Development Services
1775 – 12th Ave. NW | P.O. Box 1307
Issaquah, WA 98027
425-837-3100
issaquahwa.gov

Subject: Briefing Response Memo for Issaquah Gateway (Mull) Apartments
Site Development Permit: SDP13-00005

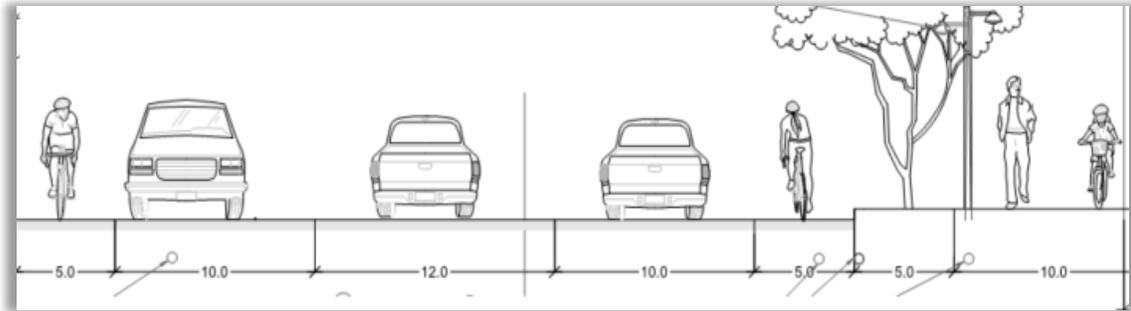
Newport Way road design for vehicles: Will there be a center turn lane? 10 ft lane widths are below street standards. Give a clear picture of what the frontage will look like. Add painting on the roadway to indicate which areas need to be kept open for turning e.g. like the grids painted on the roads with ferry wait lines.

Newport Way road design for people walking and biking: Why is the sidewalk removed on one side of Newport Way? How are we ensuring the safety of cyclists and children? Consider continuous lighting on Newport Way before or conjunction with the developments, due to increase in people walking from all of these new developments on Newport Way. Provide a multi-modal path as an alternative way into Issaquah. Drivers use the bike lanes to negotiate the curves. Doesn't the project have to provide a bridge over I-90 like it was shown in the Central Issaquah plan?

Road Design: The intersection control method and frontage improvements are separate from the Issaquah Gateway site design. The Development Commission's responsibility is to review and approve the site design and does not include the Newport Way roadway improvements. As mentioned above, Newport Way is under review by the City and their consultant as part of the crossing study currently underway.

The Gateway Project will construct its frontage improvements for Newport Way identified in the *Central Issaquah Development and Design Standards* along the Gateway Project frontage. As currently proposed the road section for this project (shown on the next page) includes a Shared Use Route adjacent to the Gateway property, together with a landscape strip separating the trail from the on street bike and west-bound travel lanes. Where appropriate, a center turn lane will be used for separating turning traffic from through travel lanes. Where a center turn lane is not required, a landscape median would separate the east-bound cars from west-bound ones. 10-foot-wide travel lanes are proposed to

promote slower speeds along the corridor, together with 5-foot bike lanes. This requires widening Newport Way right-of-way along the property's frontage to accommodate all the necessary improvements.

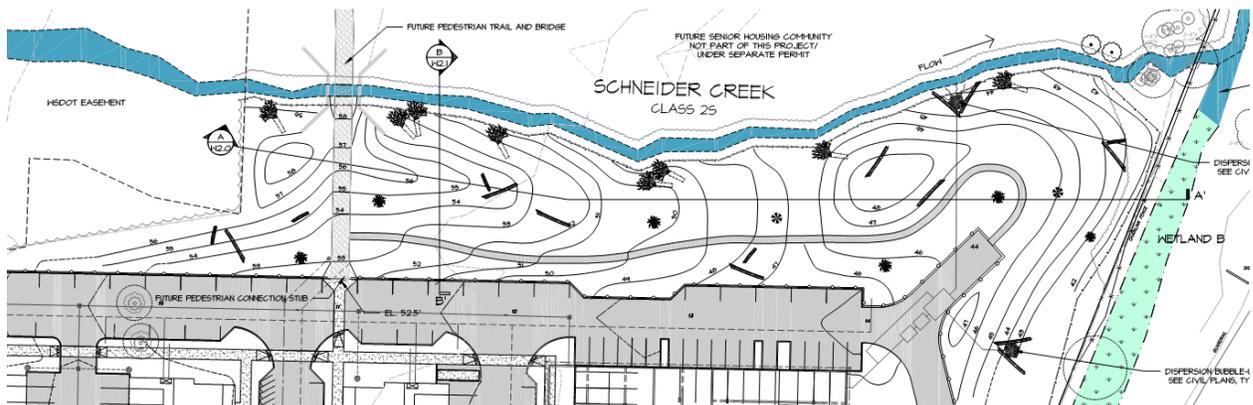
14. **Boardwalk to Rowley's property:** The height and design of the boardwalk should allow wildlife to cross under the boardwalk. Can the trail be lit through the wetland? Would there need to be SEPA offset for the impacts? Why is Tibbetts Creek shown on the Rowley Property? If the applicant doesn't own the property all the way to the 19th Ave can the City use eminent domain to ensure the boardwalk connects all the way to the road?

Staff: The height and design of the boardwalk could allow for wildlife passage, at least under some sections of the boardwalk. The code limits lighting adjacent to critical areas, but some low-level lighting, focused downward on the boardwalk to minimize spillover, will be needed for safety. The code includes standards to mitigate the impacts so this issue doesn't need to be re-addressed under SEPA. There is a future plan to relocate Tibbetts Creek into the Wolff side of the buffer. This requires coordination between Wolff and Rowley. The Rowleys have agreed to allow the boardwalk to connect to 19th Ave, and Wolfe and Rowley are negotiating the terms of that connection.

Applicant: The final design for the elevated boardwalk will allow for wildlife passage. Detailed construction drawings will be submitted to the city for review and approval. Installing lighting along the trail will be the decision that will need to be approved by the city. Typically, lighting is discouraged to be installed in wetlands. The impacts for the boardwalk have been accounted for with the current SEPA MDNS. An easement would be required with the property owner to the east (Rowley) to connect the boardwalk and bridge over Tibbett's Creek to 19th Ave.

Conclusion: Staff recommends adding a new condition to the revised Approval Conditions as follows: "The boardwalk will be designed with adequate clearance to allow for wildlife passage."

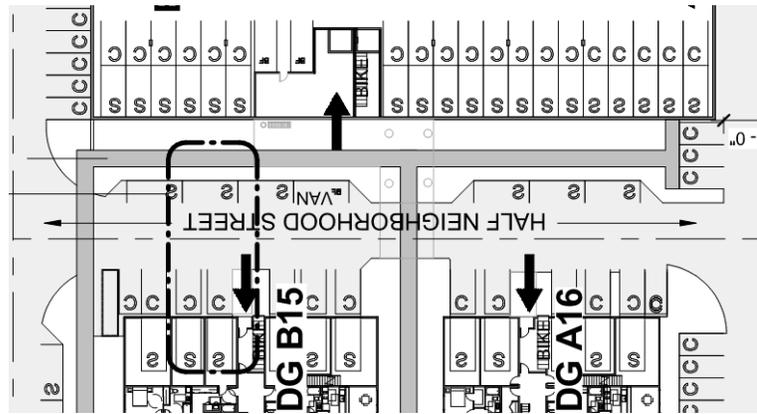
24. **Neighborhood Street #1 (adjacent to WSDOT critical area):** Why are we reducing the parking to 7 ft from 8ft? Isn't that too narrow like the roads at Issaquah Highlands? What's the difference between parking requirements for the Urban Villages and this zone, Village Residential? Per CIDDS circulation priorities (6.2.C.), it is not allowed to remove a sidewalk from one side of the neighborhood street. Why accept 10 ft sidewalk on one side if you could have 6 ft on both sides?

Staff: There are two factors at play with the Issaquah Highlands' (Highlands) streets: first the travel lanes are often 9 ft rather than the 10 ft lanes used in many Central Issaquah street standards. Second, many of the Highlands parallel parking spaces are 6 feet wide. This was later adjusted to 7 ft. As a result, the street section proposed for Issaquah Gateway is several feet wider (up to 4 ft) than many Issaquah Highlands residential streets. The 7-foot wide parking stalls are allowed in Central Issaquah through an administrative adjustment of standards (AAS) when the Director deems that this is acceptable. Lessons learned from the Issaquah Highlands are useful in determining the appropriate reduction of width that is functional for the parallel parking stalls in the Gateway Apartments. The CIDDS circulation priorities criteria are guidelines, not requirements. For this project, Staff weighed the pros and cons of a 6-foot wide sidewalk on both sides of the street or a 10-foot wide on one side. The staff analysis for granting the AAS explained that there were several advantages to having a wider sidewalk on one side of the street only.

The applicant is proposing that the parking width be 8 feet on both sides of the street with 10 foot drive aisles. The applicant is providing a 10' wide sidewalk on the traveled side of the street extending from the crossing to the West of Building B15 to the crossing to the West of Bldg C07. This has been deemed to comply with the goals of the CIDDS through multiple coordination meetings with the City of Issaquah.

Above, left: City Street Standard Detail T-36; Above, right: City Street Standard Detail T-37

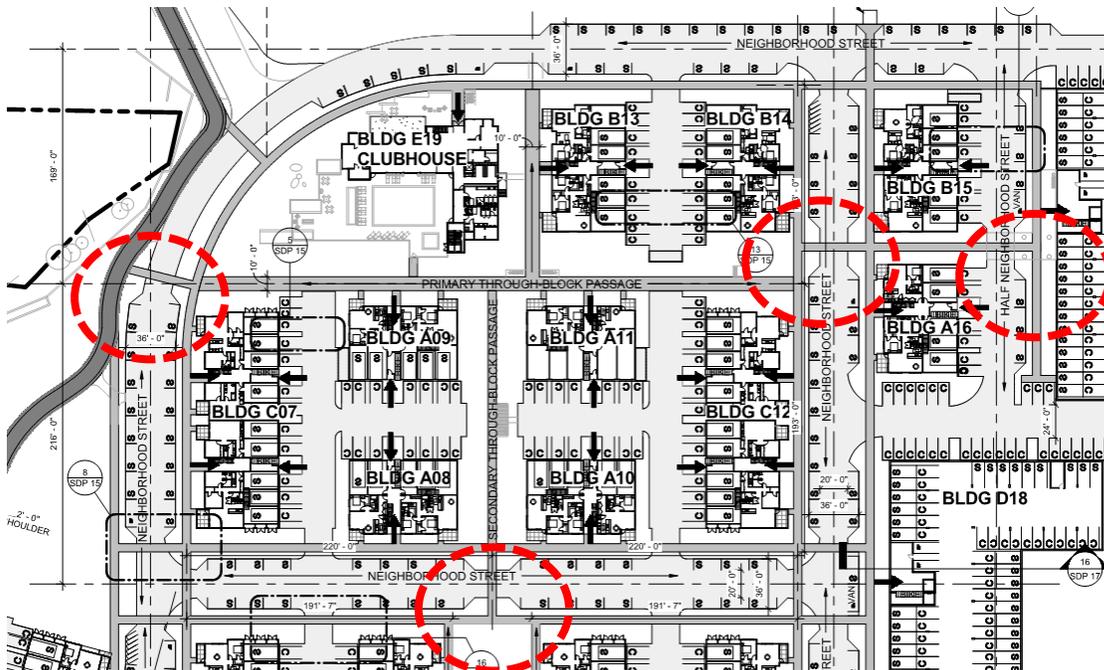
29. **SDP Condition 19 and Construction Condition 22:** Edit. Be consistent and use markings drivers are used to. This could be confusing for pedestrians too. Texture and color are difficult or impossible to see at night and color especially wears away.

Staff: The City has two standards for crosswalks. One is the traditional striping, shown at left below, next page; the other is a stamped crosswalk, as shown at right, next page. Both standards are allowed and used in the City. At the Newport Way intersection, the City will select the appropriate crosswalk marking based on the intersection control method selected.

Within the project, at street intersections, the applicant may elect to use either standard, or to not stripe these crossings. For comparison, if this was a public street, the City would not likely

mark these crosswalks. However, where trails cross the road, per CIDDS 12.4.E.2 the crossings shall be marked, consistent with the standard on the right below. See map below the crosswalk standards for locations where this standard applies.

Conclusion: Revise SDP Condition 19 Construction as follows: "All pedestrian-only crossings of roads within the project shall be paved with a distinctive material, such as concrete, compared to the asphalt travel lanes to easily distinguish for motorists and pedestrians." Condition 22 will be deleted, since striping of crosswalks is a standard already, no construction condition is necessary.
